DELEGATED APPLICATION REPORT

App Ref: PL/25/0233 Householder planning permission

Address: 2 LANCASTER CLOSE, READING, RG1 5HB

Proposal: Proposed single storey rear / two storey side and garage conversion.

Fig 3: Original submission of the proposal

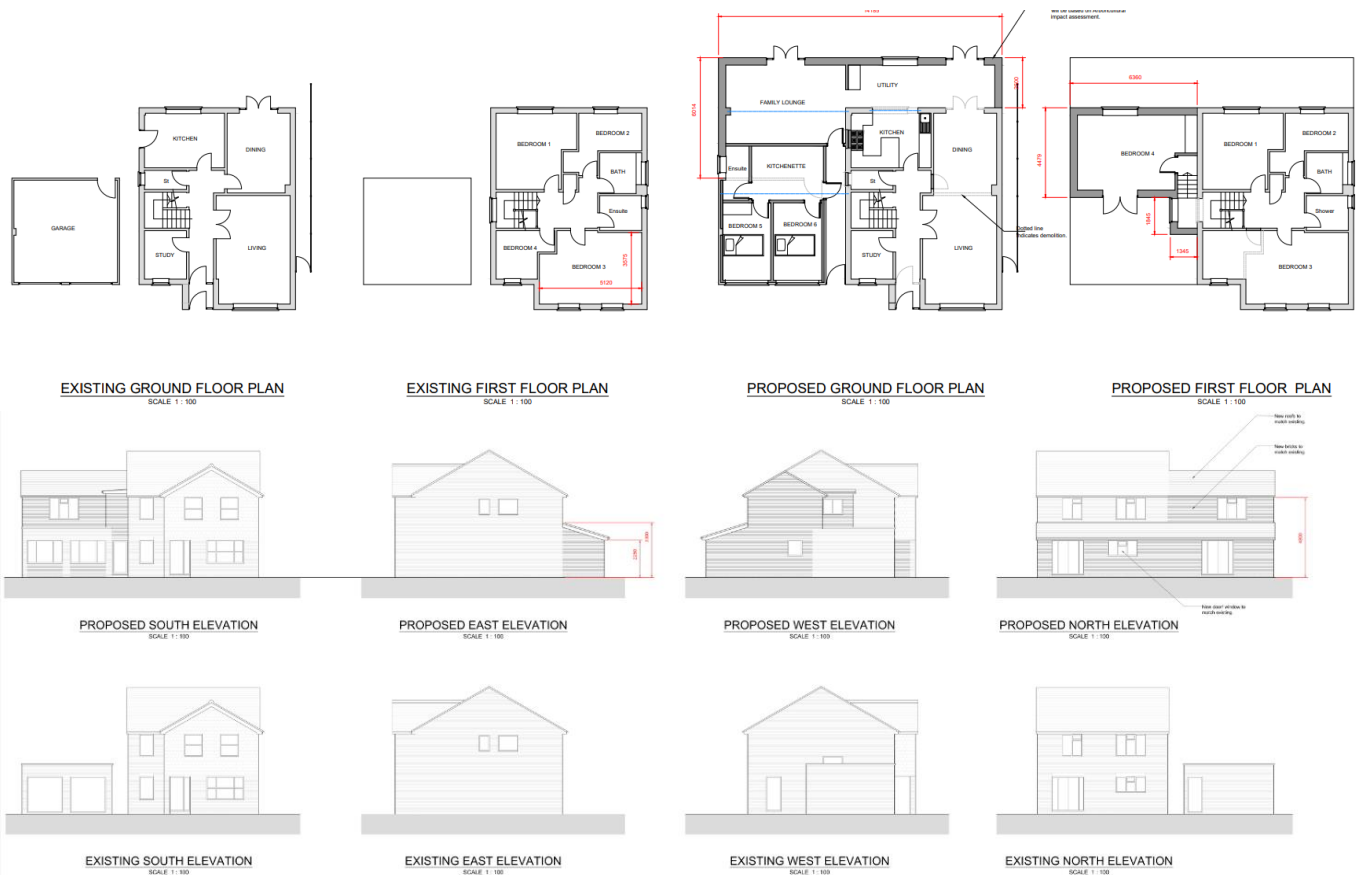
The original submission (as in Fig 3 below) posed high risks to the nearby TPO trees and did not respect the character and appearance of the existing property or neighbouring properties. It was also considered that the proposal would have significantly blocked light to, and been overbearing on, 1 Lancaster Close. An objection was also raised by the neighbouring resident.

Following advice from officers, the agent provided revised plans on 14th May 2025 showing that the two-storey side extension would be set back 1m from the shared boundary with No. 1 (Figure 4 below). The revised two-storey side extension would be partially situated above the existing garage, set back from the front elevation by 2.5m, and aligned with the existing rear building line of the main house. It would feature a gable roof, measuring ca 7m in total height. The proposed single-storey rear extension would project ca 2.5m and would extend behind the existing dwelling and beyond the line of the two storey element, almost double the width of the existing house. It would have a mono-pitched roof, measuring ca 3.3m in total height and ca 2.25m at the eaves.

Fig 5 & 6: Drawing No. 0001 (L) and Drawing No. 0003 (R)

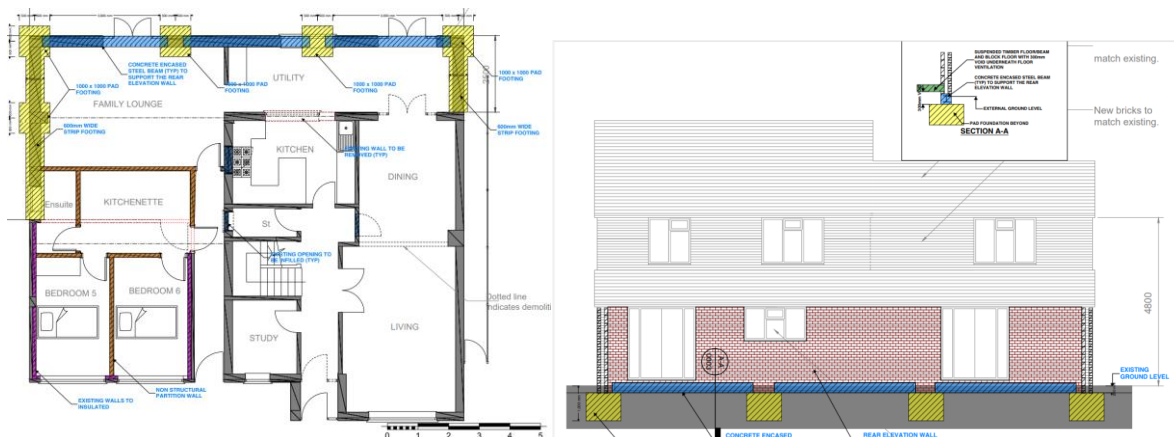
With reference to the Structural Requirements for Extension Works, May 2025, Drawings No 0001 & 0003 (below) it is recognised that 1000mm of excavation would be required to install the pad footings and 200mm of excavation required to install the concrete encased steel beams. 200mm of excavation is also required to lower the ground level under the extension. Lowering ground levels and excavation within RPAs is not acceptable as it does not comply with BS5937 2012 recommendations, particularly given the design footprint is in a significant proportion of the RPAs of Pine 01 and small proportion of Pine 03. The use of concrete within an RPA is also not acceptable as the BS5837 2012 recommends *'Due to the highly alkaline leachate produced during the curing of wet concrete, concrete should not be poured within the*

RPA unless an impermeable liner has been installed '. Impermeable liners have not been included within the design of the foundations.

Within the revised information the 'Structural Requirements for Extension Works', May 2025, Drawings No 0001 & 0003 shows that 1000mm of excavation would be required to install the pad footings and 200mm of excavation required to install the concrete encased steel beams. 200mm of excavation is also required to lower the ground level under the extension. This would be to enable the marrying up of internal floor levels and this lowering of ground levels and excavation within RPA's is not acceptable as it does not comply with BS5937 2012 recommendations, especially since the footprint of the proposal would be within a significant proportion of the RPAs of Pine 01 and a small proportion of Pine 03 (T3).
